UNITED STATES PATENT AND TRADEMARK OFFICE

10/594,849

Office Action Summary	Application No. 10/594,849	Applicant(s) BRAUER ET AL.	
	Examiner Michael J. Keller	Art Unit 3634

DETAILED ACTION

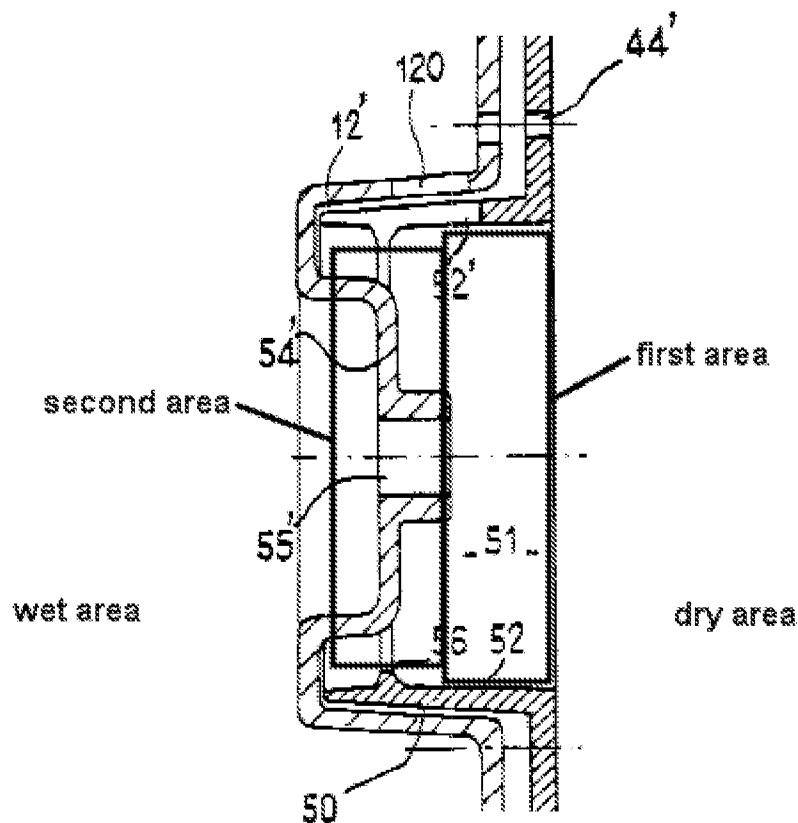
12. Regarding **claim 1**, Velthaus discloses a drum housing comprising: a mounting area; a first area of the mounting area having a first diameter; and a second area of the mounting area having a second diameter as shown in the figure below. Examiner notes that no cable drum has been claimed, and the diameters of the first and second areas are sufficient for mounting a cable drum which has been properly sized to fit within the areas.

16. Regarding **claim 6**, the first diameter is greater than the second diameter as shown in the figure below.

17. Regarding **claim 8**, Velthaus discloses a door module comprising: a carrier part 20; a drum housing mounting area; a first area of the mounting area having a first diameter; and a second area of the mounting area having a second diameter as shown in the figure above. Examiner notes that no cable drum has been claimed, and the diameters of the first and second areas are sufficient for mounting a cable drum which has been properly sized to fit within the areas.

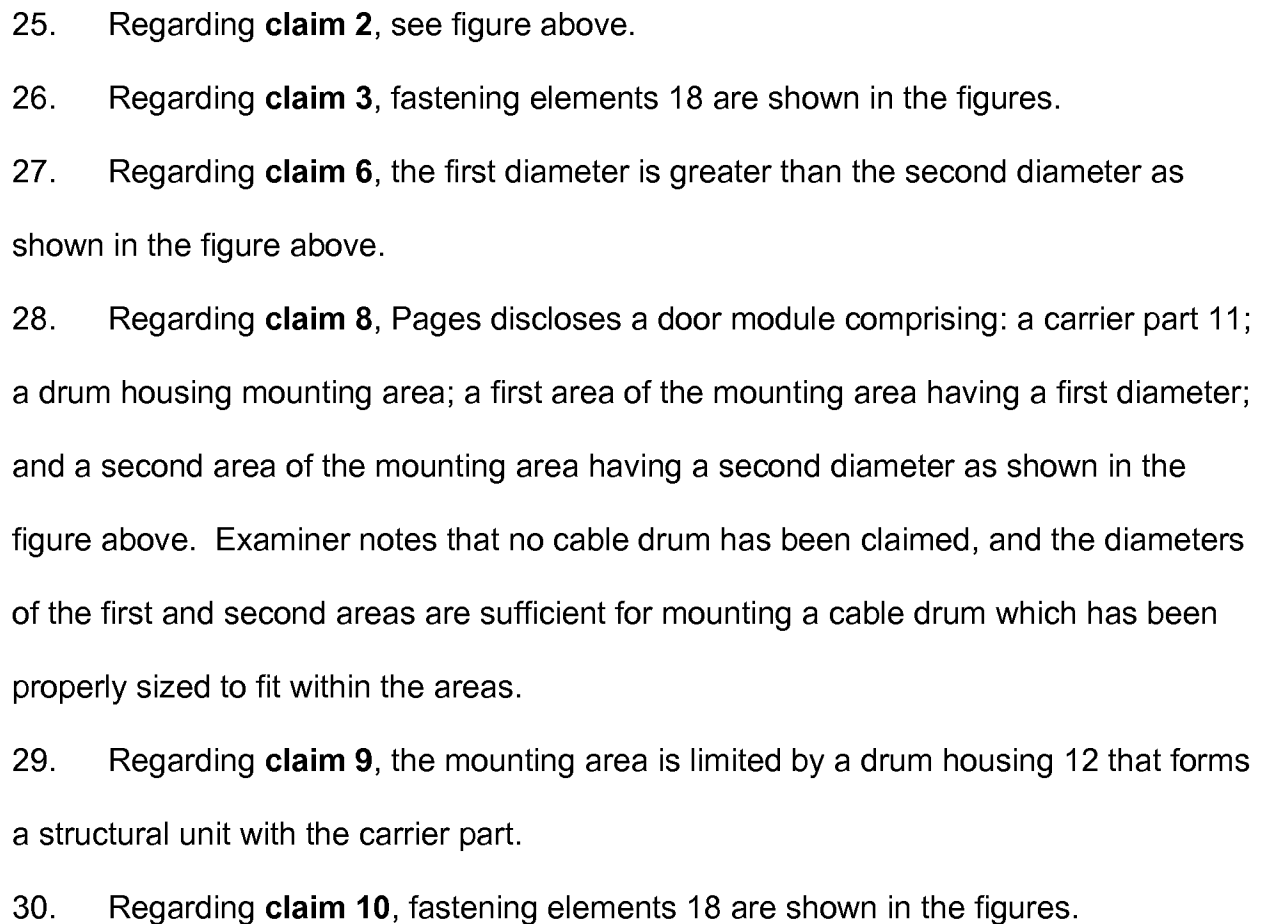
20. Regarding **claims 11 and 12**, the carrier part divides the door interior into a wet area and a dry area as shown in the figure above, and the second area faces the wet area.

21. Regarding **claim 13**, the first diameter is greater than the second diameter as shown in the figure above.

22. Regarding **claim 15**, Velthaus discloses a door of a motor vehicle comprising: a door module (Fig. 1); a drum housing 50 having a mounting area; a first area of the mounting area having a first diameter; and a second area of the mounting area having a second diameter as shown in the figure above. Examiner notes that no cable drum has been claimed, and the diameters of the first and second areas are sufficient for mounting a cable drum which has been properly sized to fit within the areas.
